Re: Onondaga Lake Capping, Dredging, Habitat and Profundal Zone (SMU 8) Final Design, Wastebed B/Harbor Brook Outboard Area Wetland Optimization Design Revision, Dated June 2016

**ONONDAGA LAKE CAPPING, DREDGING,
HABITAT AND PROFUNDAL ZONE (SMU 8)
FINAL DESIGN**

**WASTEBED B/HARBOR BROOK OUTBOARD AREA
WETLAND OPTIMIZATION
DESIGN REVISION**

WASTEBED B/HARBOR BROOK OUTBOARD AREA WETLAND OPTIMIZATION DESIGN REVISION

Figure 1 – Outboard Area Wetland Optimization Conceptual Plan

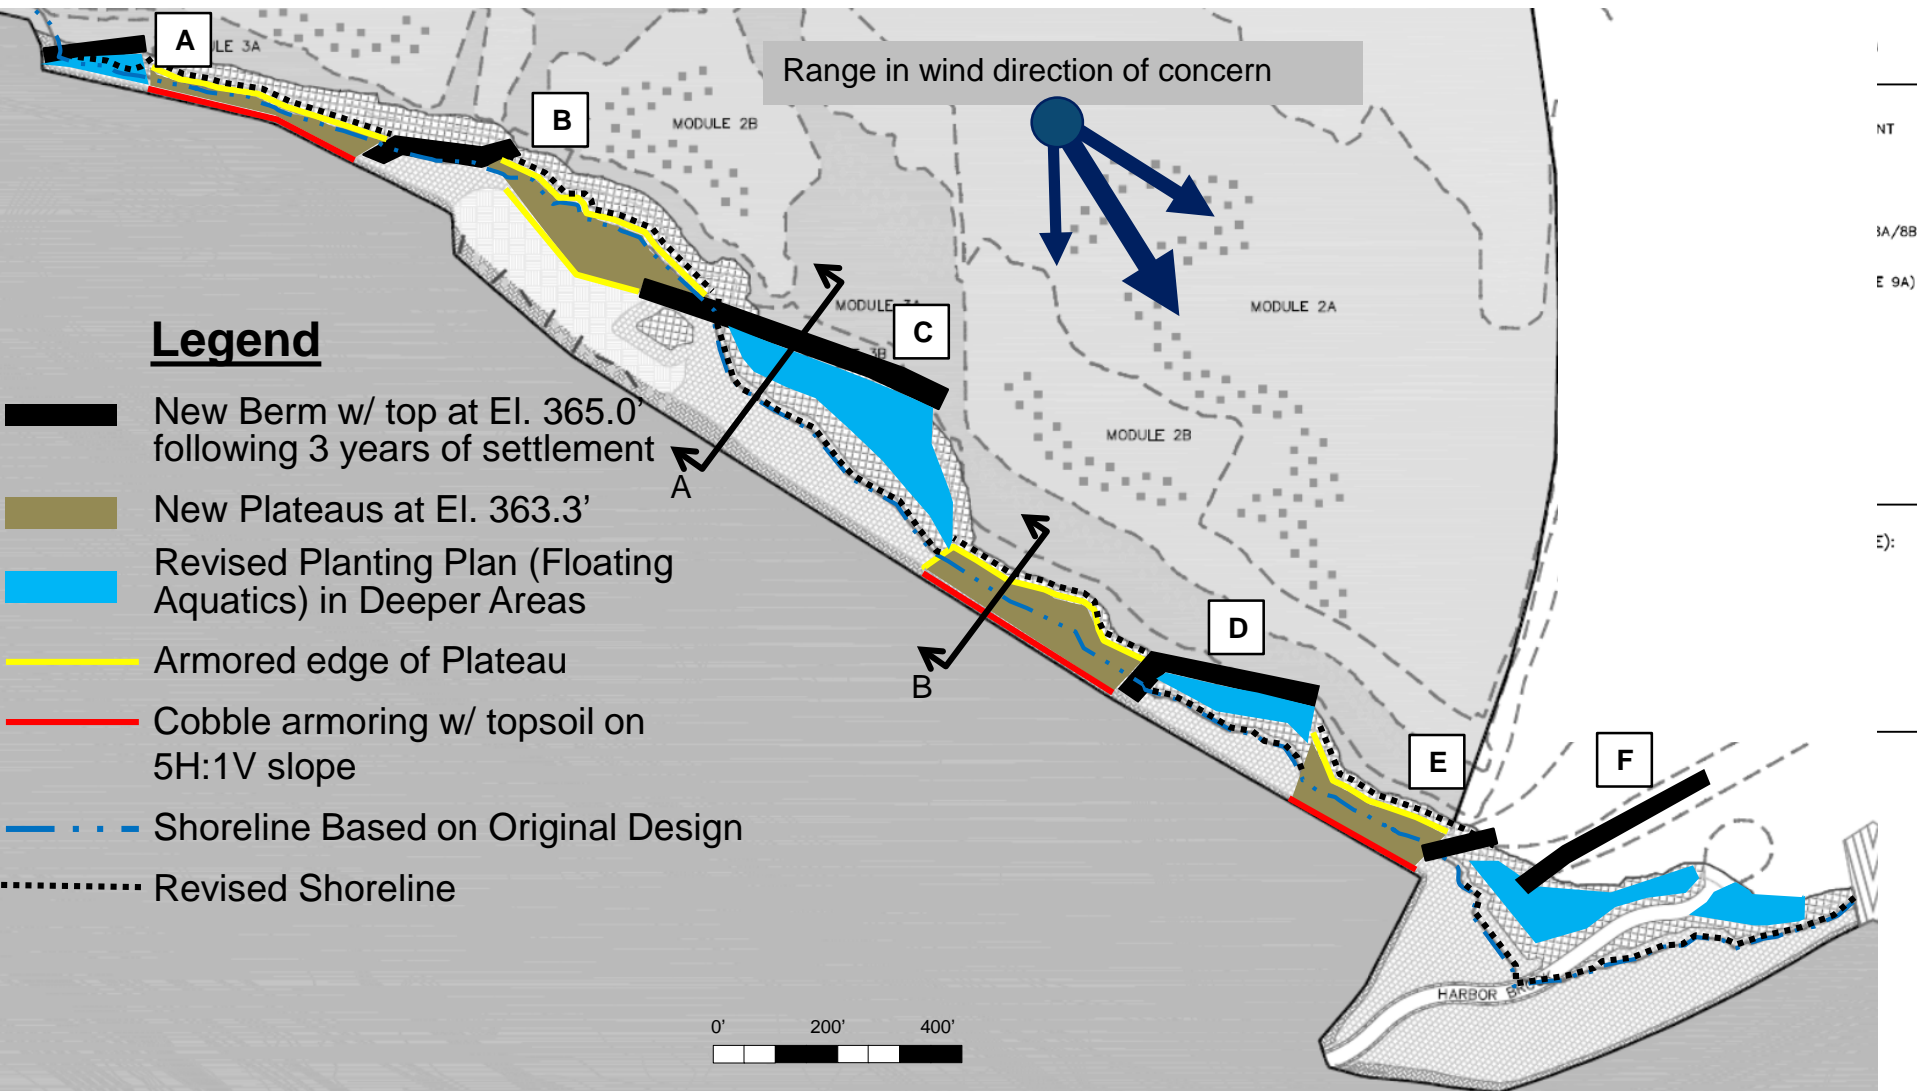
The habitat optimization components included in this design revision were developed in part based on the results from a 1.6-acre test planting area that was initiated in the western Outboard Area in 2014. Cap completion, including topsoil placement, and seeding and planting was completed in the test area consistent with the original design. As observed in subsequent monitoring, high water levels and shoreline wave energy resulted in erosion of the topsoil and loss of vegetation in the test area. The wetland optimization design will address the challenges identified during monitoring of the test planting area as well as provide additional habitat benefits. Specific revisions to the Final Design (Parsons and Anchor QEA, 2012a) are shown in Figures 1 through 3 and include:

- Berms to provide protection from wind/wave energy
- Plateaus at slightly higher elevations than the original design to provide improved conditions for establishment of wetland vegetation and reduce erosion potential in areas not directly behind the berms

The revised design incorporates six berms (labeled A through F) along the widest portions of the Outboard Area to provide protection from wind/wave energy, as shown in Figure 1. Berms E and F have been designed with a gap between them to promote water exchange between the lake and the area behind the berm where Harbor Brook discharges. The ends of berms B, D, and E that are closest to the shoreline will be offset 10 feet from the base of the slope up to the barrier wall. A typical berm cross-section detail is shown in Figure 2.

- Berm A: 365.9 feet
- Berm B: 365.5 feet
- Berm C: 365.4 feet
- Berm D: 365.3 feet
- Berms E and F: 366.0 feet

Figure 2 - Cross-Section A Typical Bermed Area

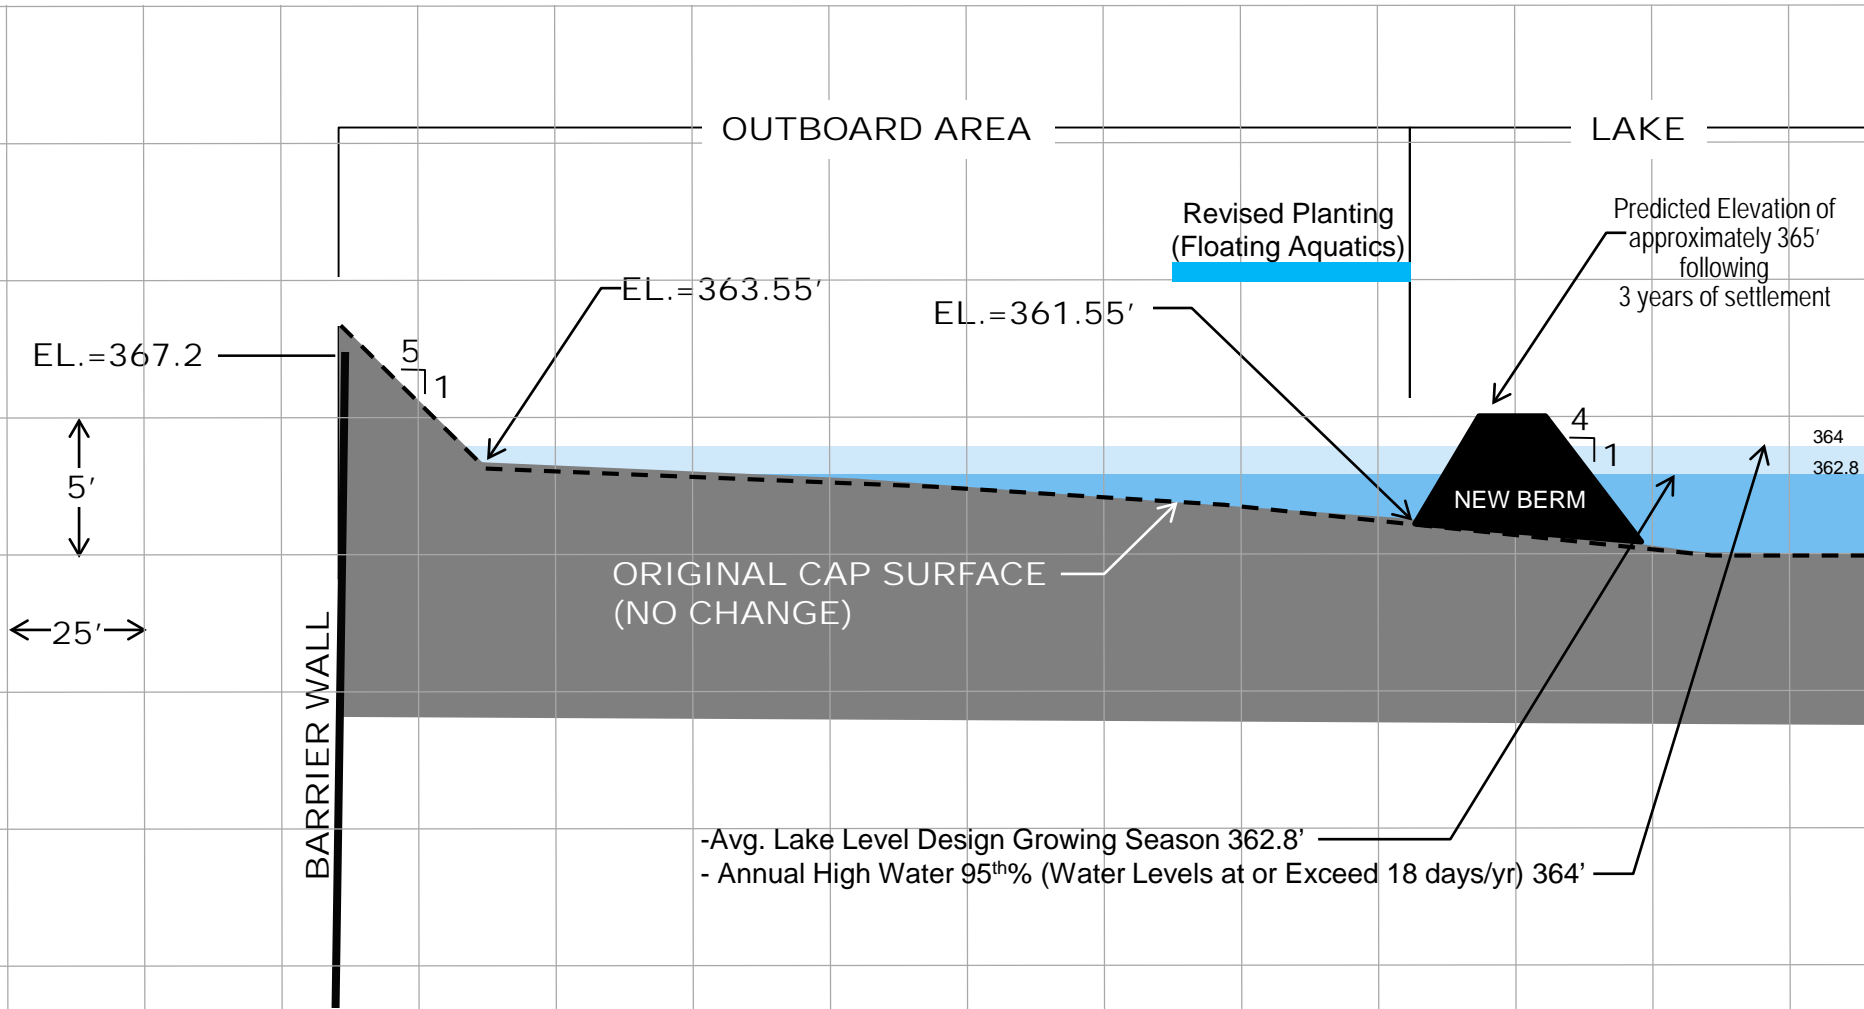
The coarse cobble (type A) will have the following gradation:

U.S. Standard Sieve Size	Percent Passing (by weight)
12 inch	90
6 inch	50
3 inch	5

The berm heights were developed to achieve an approximate top elevation of 365 feet North American Vertical Datum of 1988 (NAVD88) following approximately three years of settlement that will result due to the weight of the berm and underlying cap material. The settlement evaluation for the berms was performed consistent with the methods detailed in Appendix E of the Final Design Report for predicting settlement due to cap placement. This involved use of data collected from cores during the pre-design investigation and laboratory consolidation test results using both conventional odometer methods and the seepage-induced consolidation methods. Settlement predictions were based on consideration of underlying sediment properties, the amount of dredging prior to cap placement, the underlying cap design, the berm height, and the water depth in the area where the berm is located. Based on all of these considerations, the predicted settlement for Berms E and F is the greatest and therefore they have the highest target design elevation immediately following construction. Resulting design elevations for the top of the berms immediately following construction are listed below.

Figure 3 - Cross-Section B Typical Plateau Area

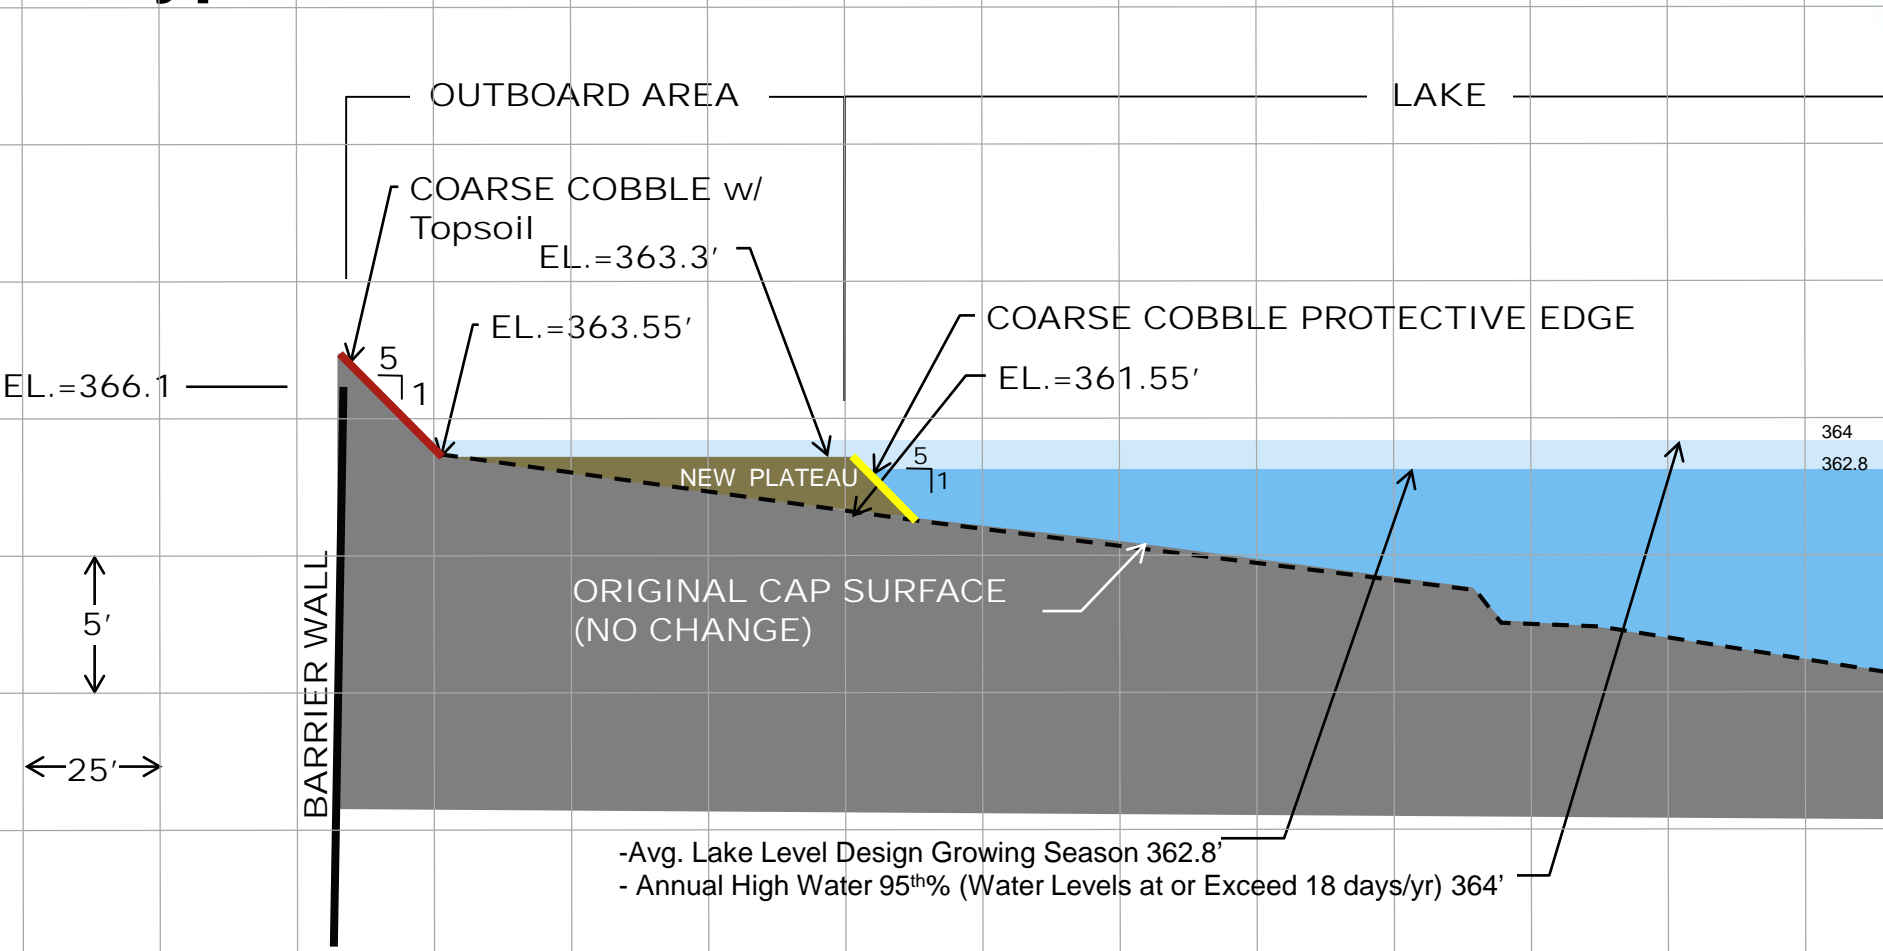
Plateaus at an elevation of 363.3 feet will be incorporated into previously sloped areas not directly protected by berms. The cap surface in these areas as well as in the areas behind the berms originally consisted of a uniform slope from elevation 363.25 to 361.25 feet, as detailed in the Final Design. These elevations were slightly increased as documented in Capping Field Change Form 22 such that the cap slope ranged from 363.55 to 361.55 feet to account for higher average lake elevations during the growing season than was assumed in the Final Design (362.8 feet vs. 362.5 feet assumed in the Final Design). The creation of the plateaus will result in more appropriate elevations for establishment of emergent wetland vegetation and reduce the potential for erosion in these areas.

A protective edge consisting of coarse cobble will be incorporated into the lake-side edges of the plateaus to help prevent erosion of the outer edge of the topsoil plateau, as detailed in Figure 3. The coarse cobble (type B) will have the following gradation, which will be resistant to the erosive forces that may be encountered in a 100-year storm event:

U.S. Standard Sieve Size	Percent Passing (by weight)
9 inch	100
6 inch	50
3 inch	5

These edges, as well as the lake-side slopes of the filled hot spots discussed below, will be at a 5 horizontal: 1 vertical slope (5H:1V). More gradual slopes were considered to reduce the erosive energy on these slopes. However, maintaining a 5H:1V slope results in a shorter slope area which will minimize the area that will have a substrate consisting of coarse cobble rather than topsoil. The design revision also includes use of coarse cobble on the 5H:1V edge of the forested wetland plateau between berms B and C and on the short 5H:1V slope from the plateaus to the top of the barrier wall to minimize the potential for erosion along these slopes.
